<b>APPLICATION NUMBER:</b>	PLN-26-028
<b>PROPOSED DEVELOPMENT:</b>	Addition to existing multiple dwelling
<b>LOCATION:</b>	8A Chestnut Avenue Lutana
<b>APPLICANT:</b>	G O'Halloran
<b>ADVERTISING START DATE:</b>	18/04/2026
<b>ADVERTISING EXPIRY DATE:</b>	02/05/2026

**PLANNING APPLICATION – 8A CHESTNUT AVE, LUTANA**  
**DWELLING ALTERATIONS AND ADDITIONS; APPLICATION NO: PLN-26-028**

Further to your request for additional information regarding this application, we provide the following responses and the revised drawings Ap01.A to Ap05.A attached:

PROJECT No. 25.257 DRAWING No. Ap01 REV. A

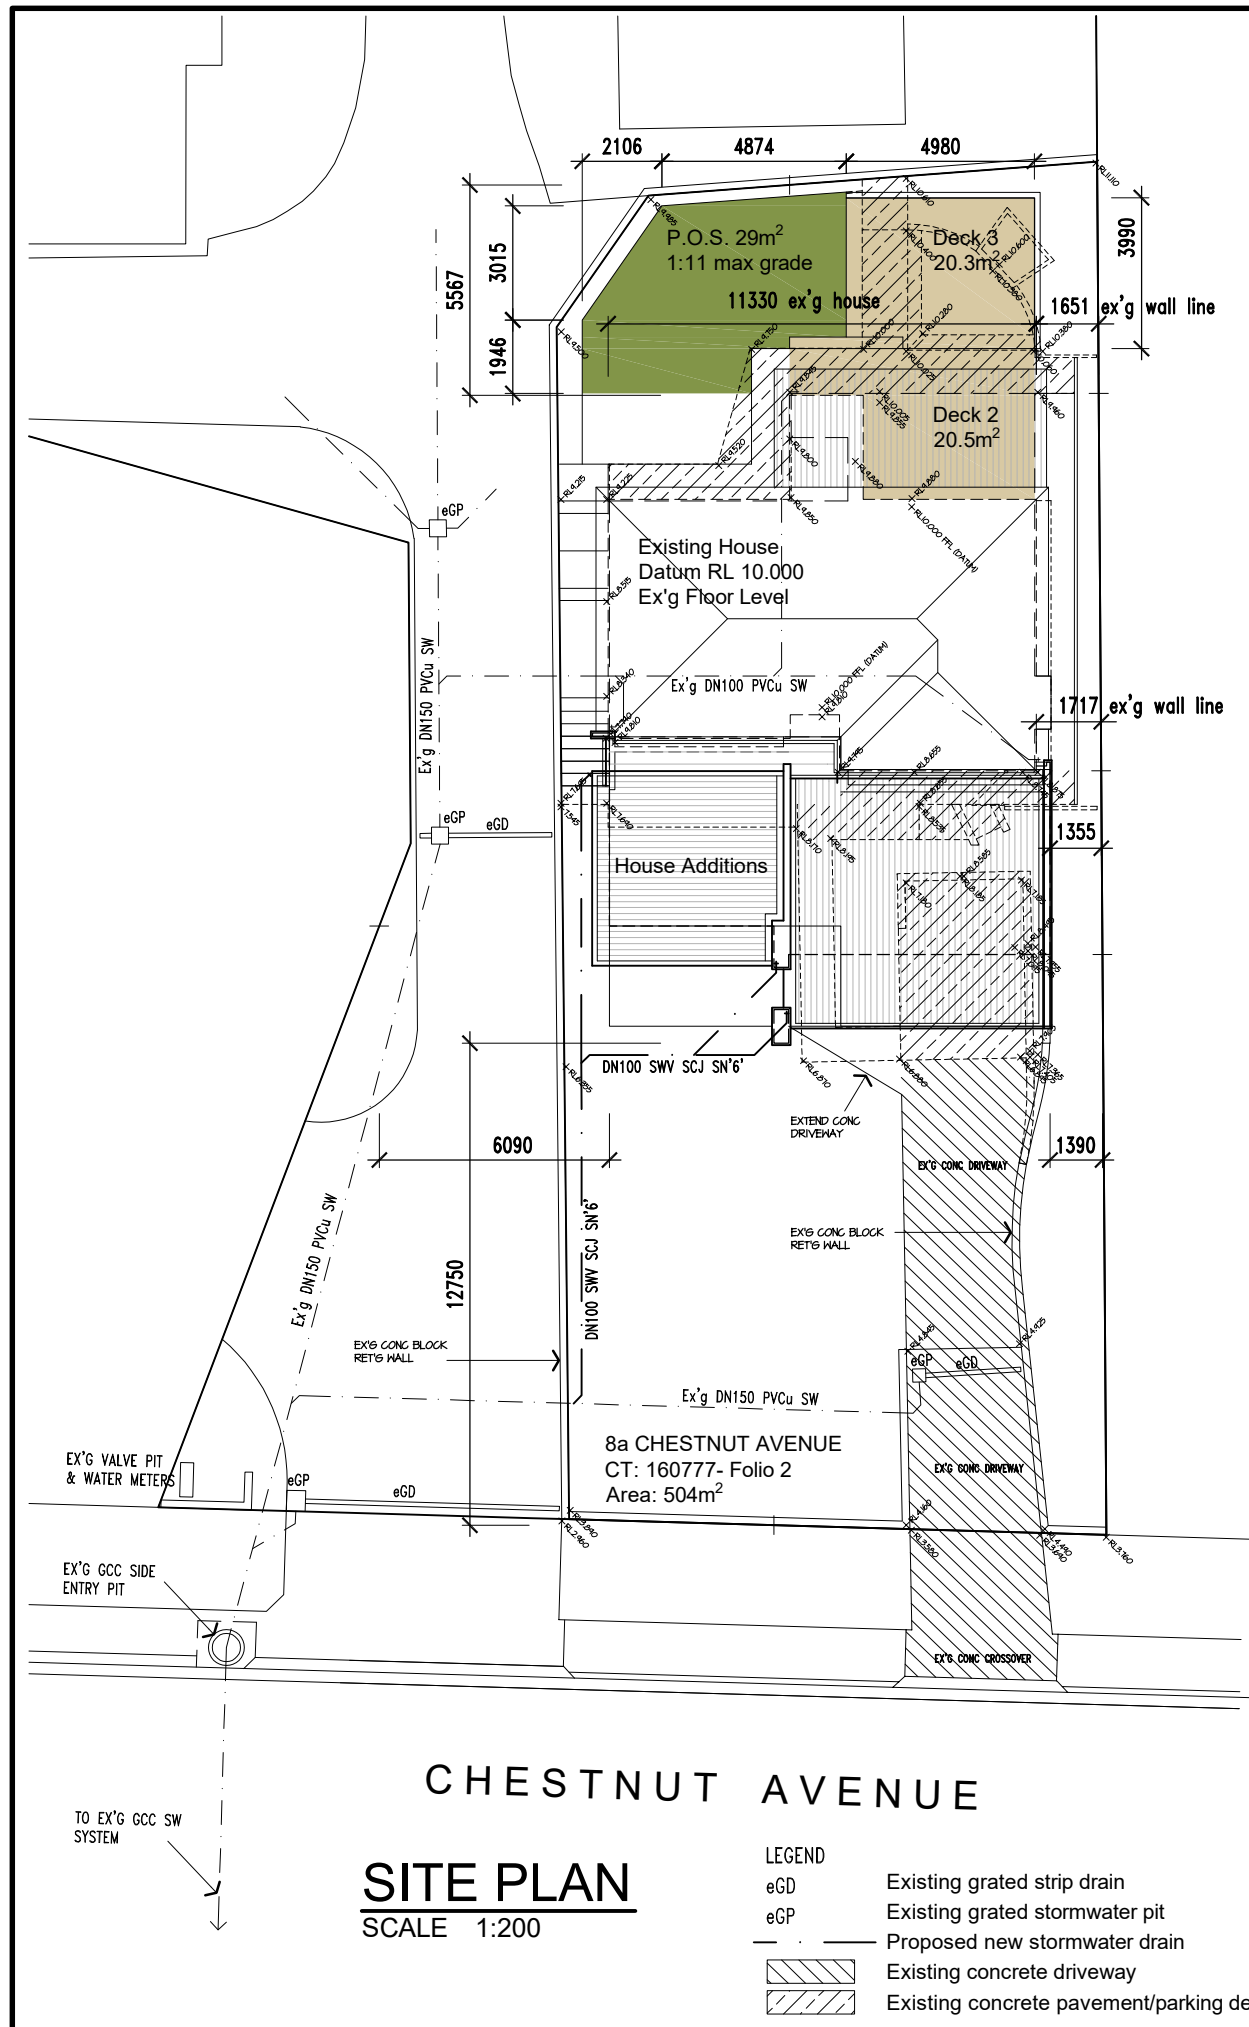
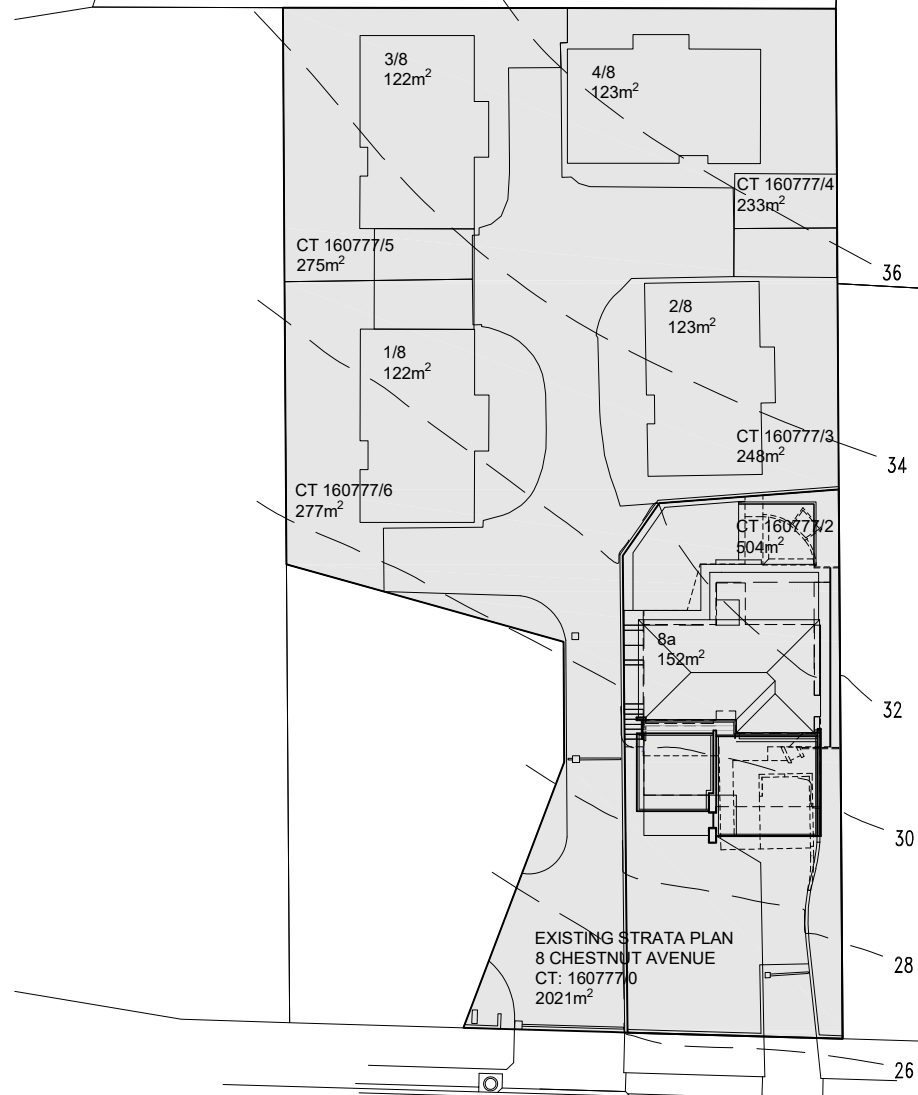
- 2. Please provide 2m contours on site plan*

- 3. Please show private outdoor space with dimensions and grade, usually a 4m x 6m green rectangle. Please address performance criteria of 8.4.3 P2 if relying on performance criteria*

- 4. Please show site coverage on plan (this is for the whole site including all units)*

- *Driveway, parking and any new hardstand areas must be constructed and compacted to standards with paved/sealed surface, provide a driveway plan demonstrating the requirement.*
- *Please provide a stormwater concept plan showing the capture and disposal of all stormwater run-off from the proposed driveway, parking and any new hardstand areas to Council's approved outlet. A concept stormwater plan in accordance with the Stormwater policy is required. All runoff must be drained via gravity to the existing or proposed outlet to Council's satisfaction. 1% minimum fall toward the outlet must be achieved. Spot levels and edge treatment shall be provided on the plan.*

1. *Provide a concept stormwater servicing plan showing the location of services and their connections to public infrastructure. The servicing plan must clearly indicate the following:*
  - a. *How all additional stormwater from the site, including hardstand drainage, driveway, and parking areas, as well as any detention, will be discharged to council infrastructure with sufficient receiving capacity.*
  - b. *Display all existing and proposed stormwater lines and connections, along with the profiles of the proposed lines.*

2. *According to the Council's Stormwater Management Policy, any development that adds an impervious area greater than 40m<sup>2</sup> and exceeds the maximum allowed peak runoff must include OSD. For any additional impervious surface greater than 250m<sup>2</sup>, please submit engineering calculations for the OSD design in accordance with the Council's Stormwater Management Policy. The policy is available on the Council website.*

Refer Location Plan on drawing Ap01.A.

Advice notice: Contours relate to state datum, spot levels relate to site designated arbitrary datum RL10.000 at upper finished floor level.

As noted in Section 4 of the permit application, there is north facing level private outdoor deck space exceeding 24m<sup>2</sup> proposed for this development. Refer Site Plan drawing Ap01.A for additional identified open space.

The proposal complies with the Acceptable Solution clause 8.4.3 A2 (a)(b)(c)(d).

Total site coverage for the Strata Scheme on completion of this project is tabulated on drawing Ap01.A. Site coverage excluding eaves overhangs is 32.9% and in compliance with the Acceptable Solution clause 8.4.3 A1 (a).

The existing concrete driveway and stormwater run-off capture/disposal will remain as is and will include minor adjustment of grade and width only at the interface with the carport, refer Site Plan on drawing Ap01.A.

Existing and proposed stormwater services are shown on Site Plan drawing Ap01.A. Discharge is via a single additional connection to the existing domestic stormwater main within Lot 2 as shown, no new direct connections to GCC infrastructure are proposed.

This development adds 37m<sup>2</sup> of impervious area therefore the requirement for on-site detention is not applicable, refer Impervious surfaces table on drawing Ap01.A.

PROJECT No. **25.257** DRAWING No. **Ap02** REV. **A**

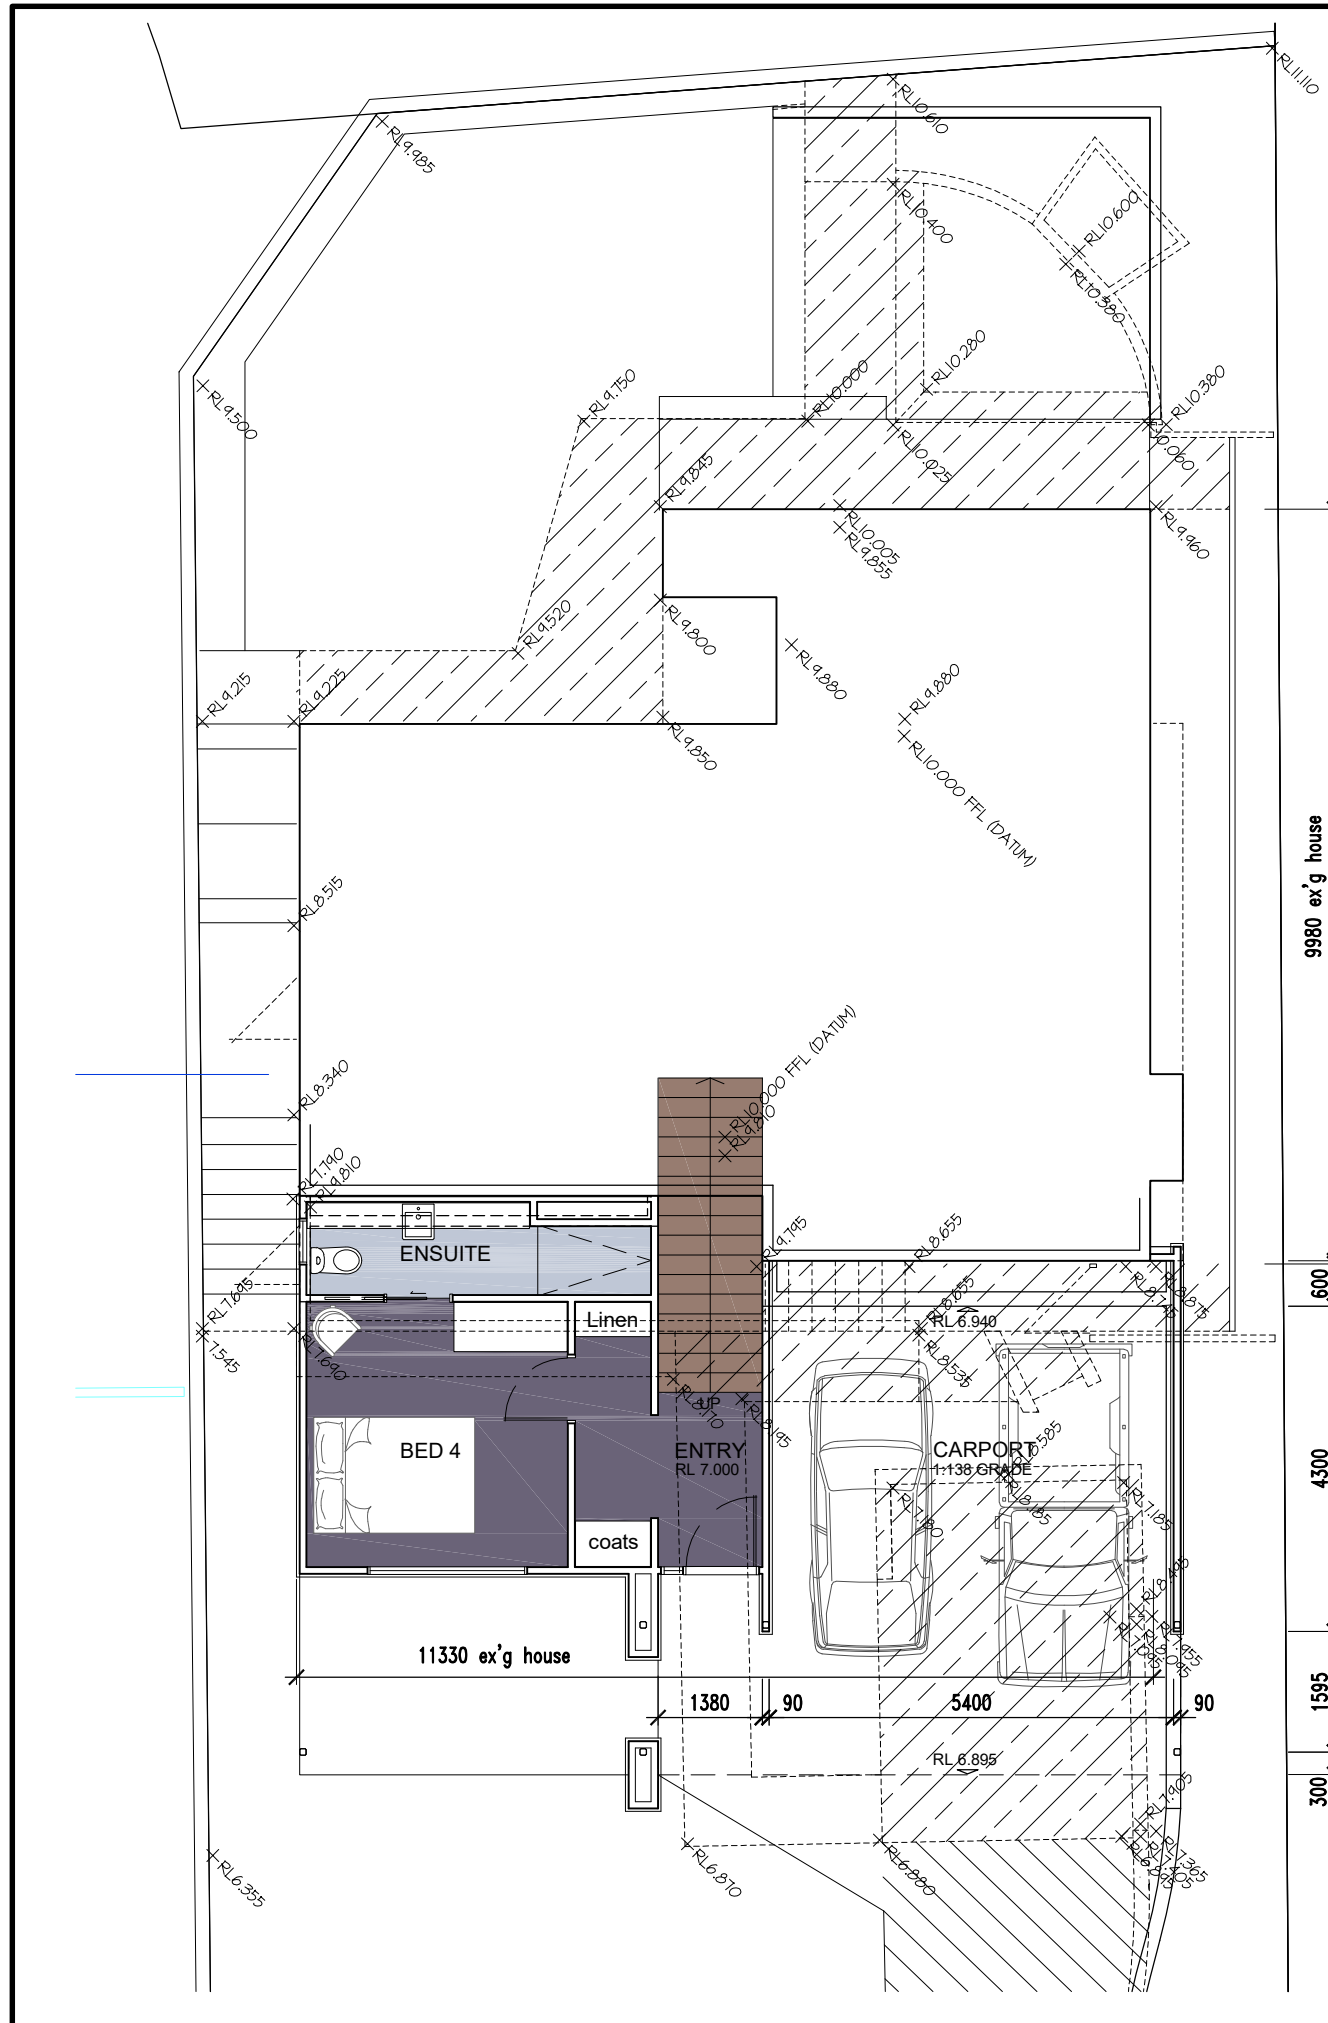
- 5. Please show dimension of garage opening*

*7. Please show staging on all plans*

*Please show and locate on the plan numbers of proposed car parking spaces; and clarify with the acceptable solution, A1, is met.*

Carport opening dimensions are shown drawings Ap02.A and Ap04.A.

As submitted in the Planning Application Form this proposal is not a staged construction project. Inadvertent reference to Stage 2 in the drawing title on drawing Ap02 is removed.

There is provision for two cars in the proposed carport shown on drawing Ap02.A. Carport dimensions comply with the requirements of AS/NZS 2890.1 Figure 2.2(d) and Figure 5.2 for User Class 1A and clauses 5.3 Headroom and 5.4 Design of enclosed garages, specifically 5.4(b)(i).

- Width: 2 spaces x 2.4m+0.3 door space outside of each outer space i.e., 5.4m wide.
- Length: 5.9m.
- Unobstructed clear opening height: 2.56m.
- Floor gradient: 1:138.
